|                               |                                                                                                                      | STANDARD DESIGN - 24' ROADWAY, THREE SPAN BRIDGE<br><b>PRETENSIONED PRESTRESSED<br/>CONCRETE BEAM BRIDGES</b><br>DECEMBER, 2006                           |           |
|                               |                                                                                                                      | SUBDRAIN DETAILS                                                                                                                                          | H24-78-06 |

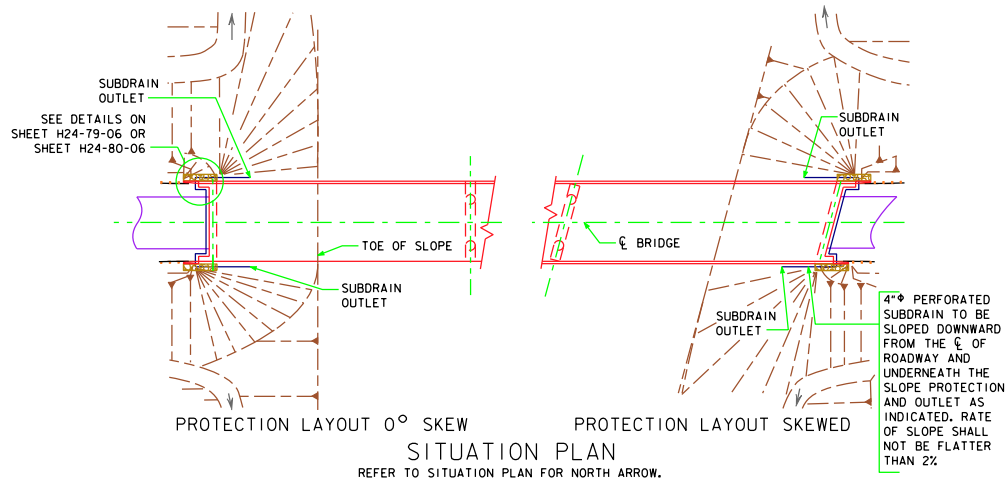
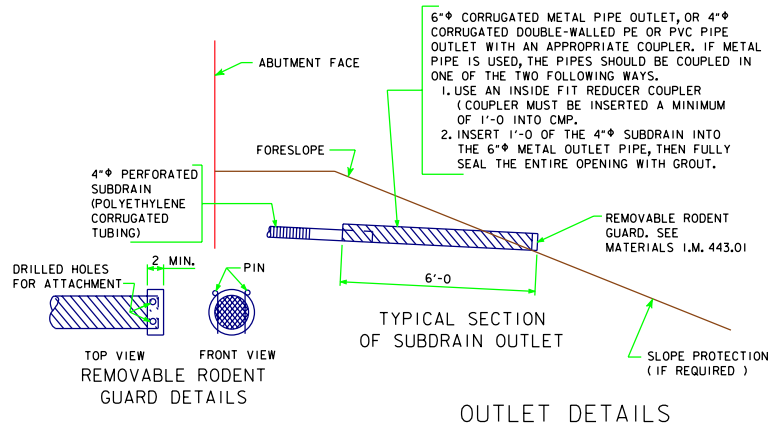
REVISED 01-10 - REMOVED THE GRANULAR BACKFILL DETAIL.
